ANN ARBOR HISTORIC DISTRICT COMMISSION**Staff Report****ADDRESS:** 502 S Second Street, Application Number HDC22-1071**DISTRICT:** Old West Side Historic District**REPORT DATE:** May 12, 2022**REPORT PREPARED BY:** Jill Thacher, Historic Preservation Coordinator**REVIEW COMMITTEE DATE:** May 9, 2022**OWNER****APPLICANT****Name:** Scott Wedemeyer

APPLICATION: The applicant seeks HDC approval to construct a 172 square foot second-floor addition on top of a single-story rear wing.

502 SECOND ST PROPOSED ADDITION

① First Floor Plan
1/8" = 1'-0"

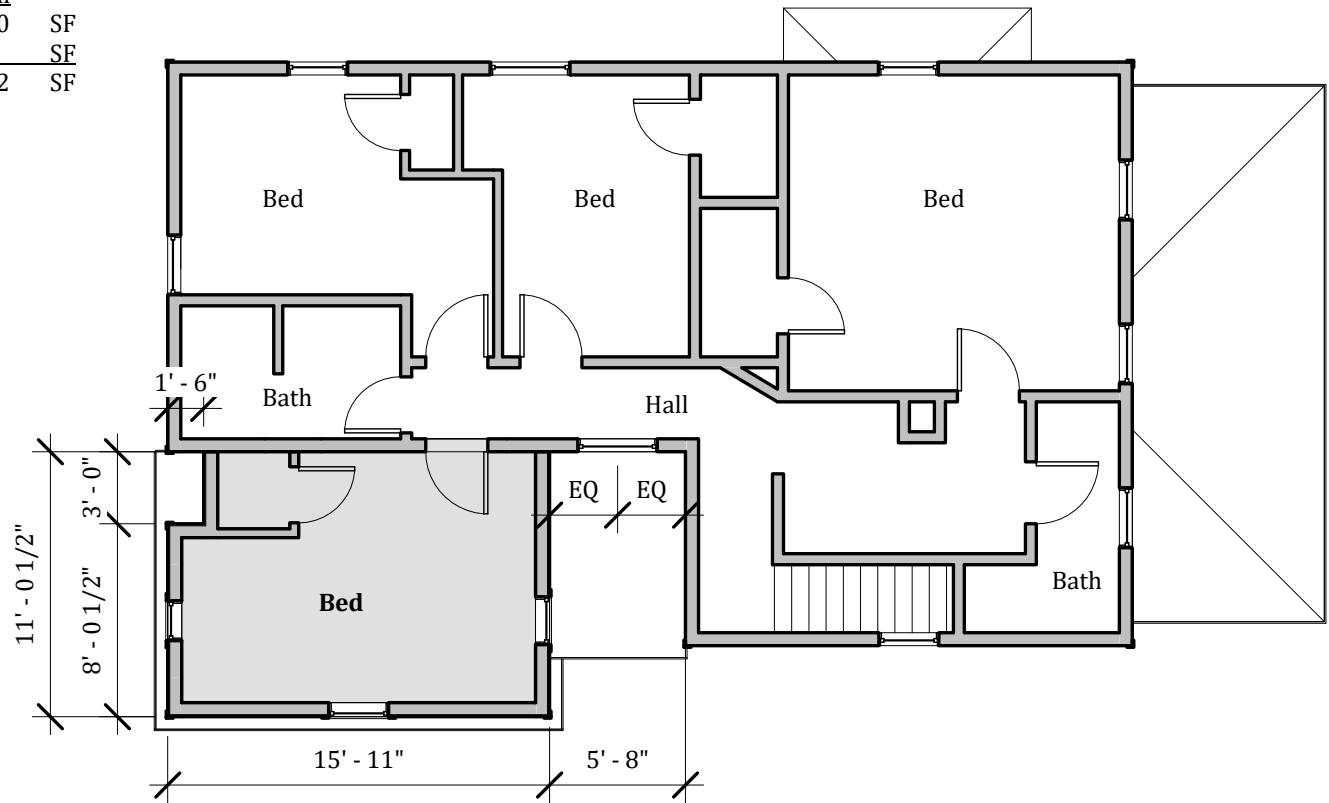
2. The house is currently 1840 square feet, and the footprint is approximately 1036 square feet. The addition would add 172 square feet. The total increase in floor area is 9% and footprint is 0%, well within the design guideline recommendations.

1 South Elevation
 1/8" = 1'-0"

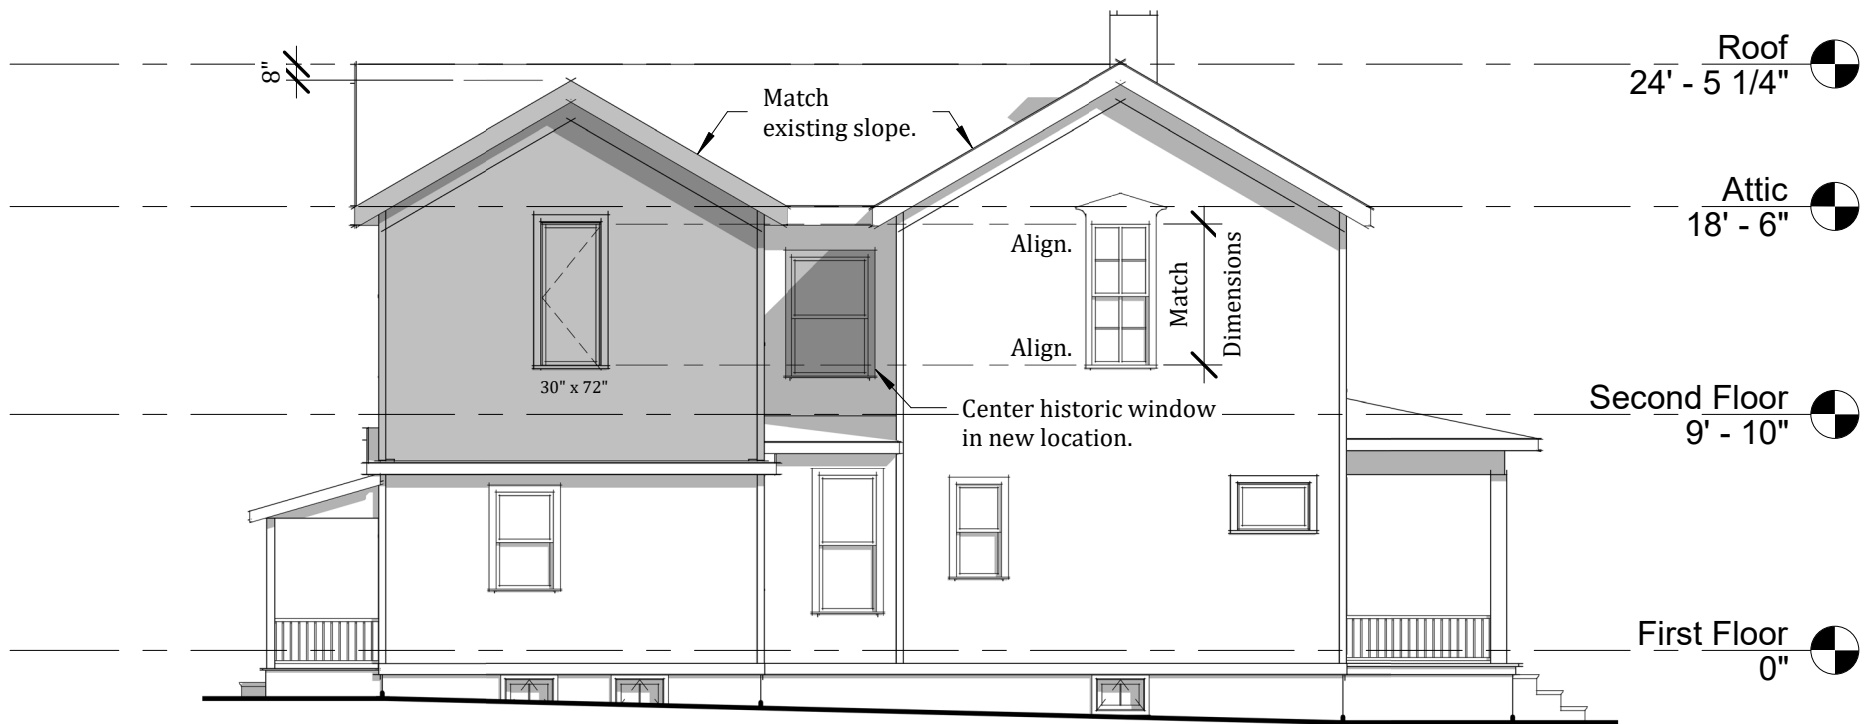
5. There is one smaller one-over-one window on the south wall that would be lost to the addition. Its age is unknown. A second window would be shifted three feet to the east to allow the addition to sit atop a first-floor load-bearing wall. Three new windows are proposed on the addition. One matches the dimensions of a prominent window on the second floor of the same elevation and another matches the dimensions of a first-floor triple-window on the same elevation. Though the styles (casement and awning) of the windows do not match the existing historic ones, staff has some concerns about matching the window dimensions exactly. Whether the trim dimensions will match is not indicated. The addition is compatible with the historic house and differentiated by the window design, first floor eave trim, and west elevation inset on the addition.

① West Elevation
1/8" = 1'-0"

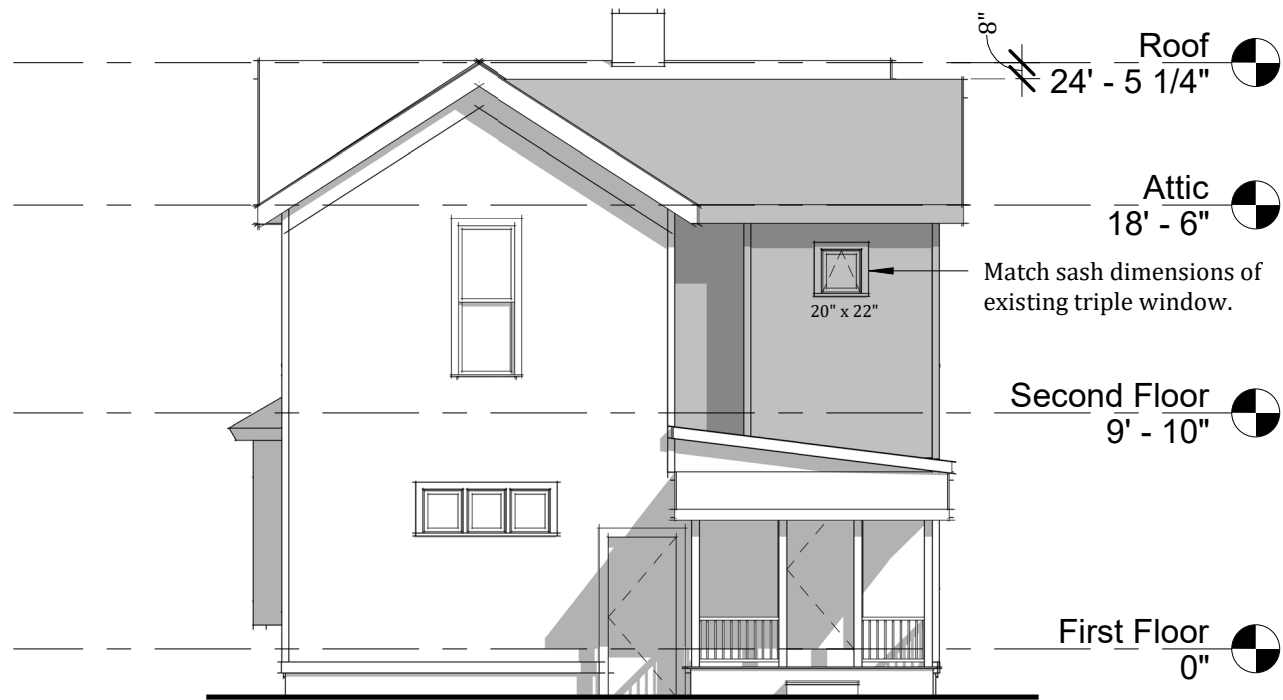
4. Two windows on the rear elevation would sit atop the existing shed-roof one-story wing. Trim matching the existing shed roof would be maintained as a record of the original roof plane. On the west/rear elevation, the addition would be inset by 1 ½' for the 3' closest to the existing house. This break provides relief from an otherwise flush wall plane and maintains the original rear 2nd story corner of the house. The east wall of the addition has a natural break provided by a small one-story section with a different (existing) roof plane.
